OPERATIONAL TEST
AND EVALUATION

MEMORANDUM FOR UNDER SECRETARY OF DEFENSE FOR ACQUISITION,
TECHNOLOGY AND LOGISTICS
SECRETARY OF THE AIR FORCE
CHIEF OF STAFF OF THE AIR FORCE

SUBJECT: Achieving Full Combat Capability with the Joint Strike Fighter (JSF) is at
Substantial Risk

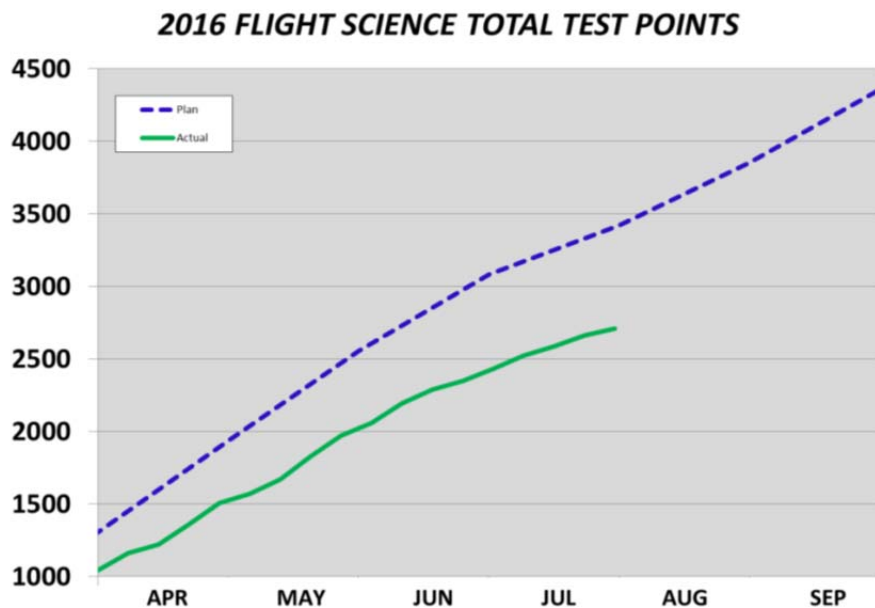
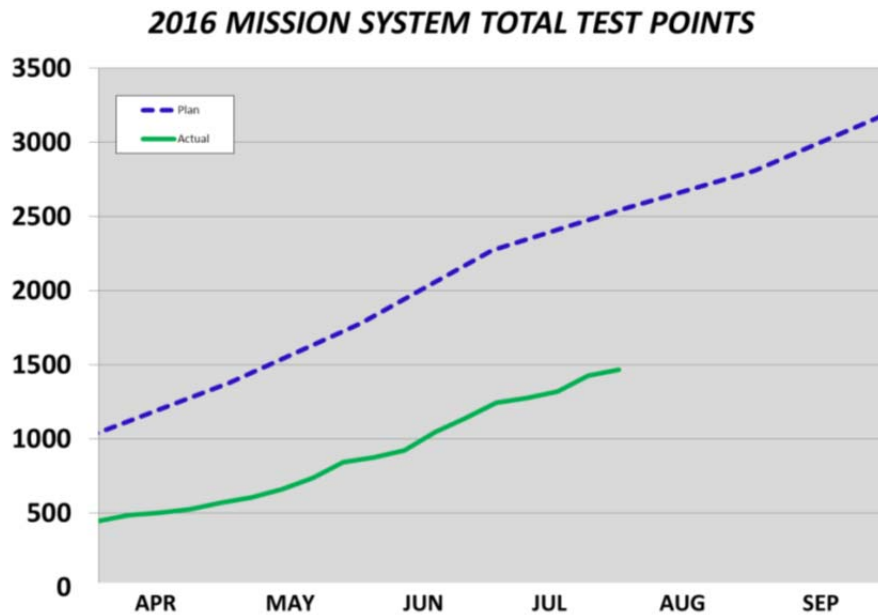
- The program is behind in flight testing of Block 3F mission systems and flight sciences testing, and is still not catching up due to a combination of factors (e.g., aggressive schedule, new discoveries, regression testing, and normal attrition for reasons like ground aborts, weather and airspace), as indicated in the program office test point completion progress charts for 2016 shown below:

How the program will be able to accomplish the balance of required test points remaining in the time and budget allotted, given historic rates and ongoing personnel reductions, is unclear.
